Single-Family Home – Fourplex Building Design Standards

Matt Bodine
Assistant Planner
1/12/2026

Garage Design – J-Swing

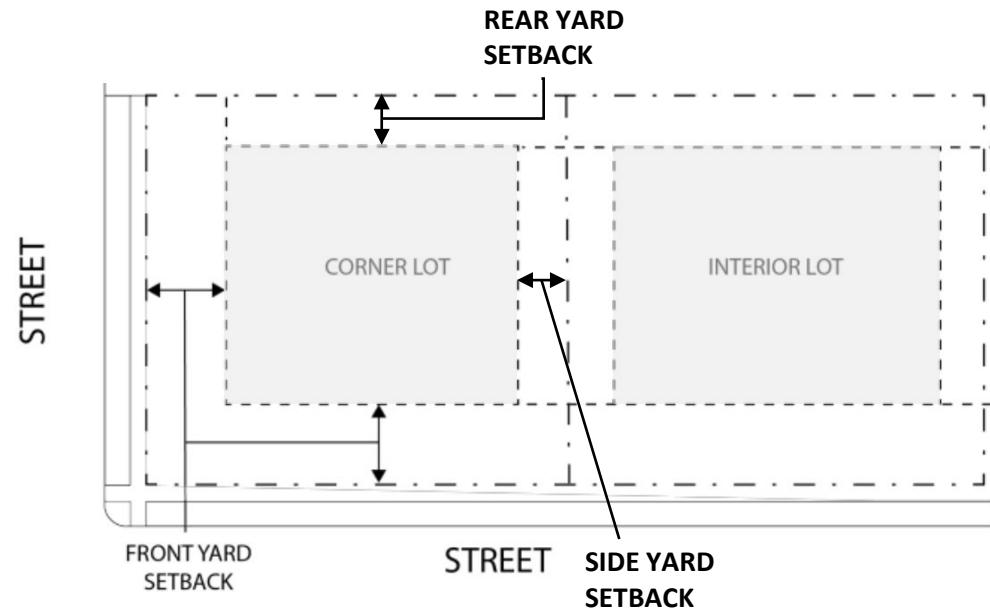
Current Standards:

- Side-entry and rear-entry garages may encroach into setbacks.
 - Must maintain a 10-ft front yard setback and 5-ft rear yard setback.

Proposed Changes

- Allowing J-swing garages to encroach into setbacks.
 - Must maintain 10-ft front yard setback.

Figure 7.10-A: Architectural Variety

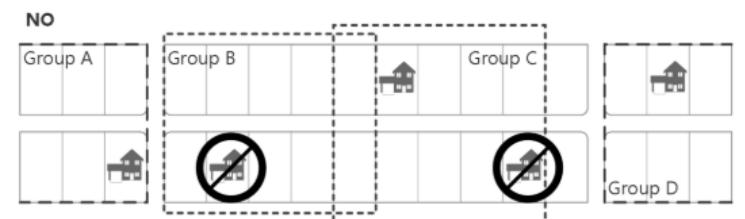
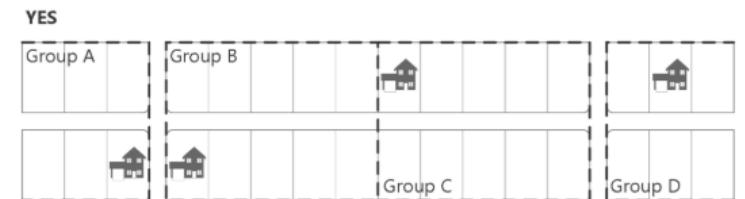
The same elevation shall not be used within any 10 lot grouping as defined by the two adjacent lots on either side of the subject property and the five lots immediately across the street from those same lots. This requirement shall not apply across a right-of-way dividing two adjacent blocks.

- There's been confusion over "10-lot grouping" language.
